# <u>SERVICE NOTE</u>

## 4155C Semiconductor Parameter Analyzer

Serial Numbers: JP10J00101/JP10J00676

LCD Picture Intermittently Reverses or is not Displayed

#### Front panel assembly

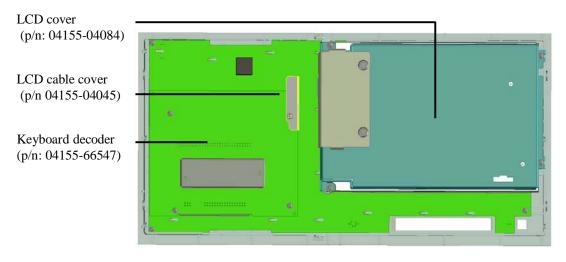
The 4155C within the listed serial number range may have the problem that the LCD picture intermittently reverses or is not displayed. The cause of the problem is that the PC board stresses the LCD cable, and the cable connection becomes loose.

When the 4155C is sent to Agilent service center for a repair, check if the LCD cable is securely connected, and add the LCD cable cover (p/n 04155-04045) to prevent the stress from the PC board.

After the LCD cable cover is installed, execute the display diagnostics to check the LCD functionality.
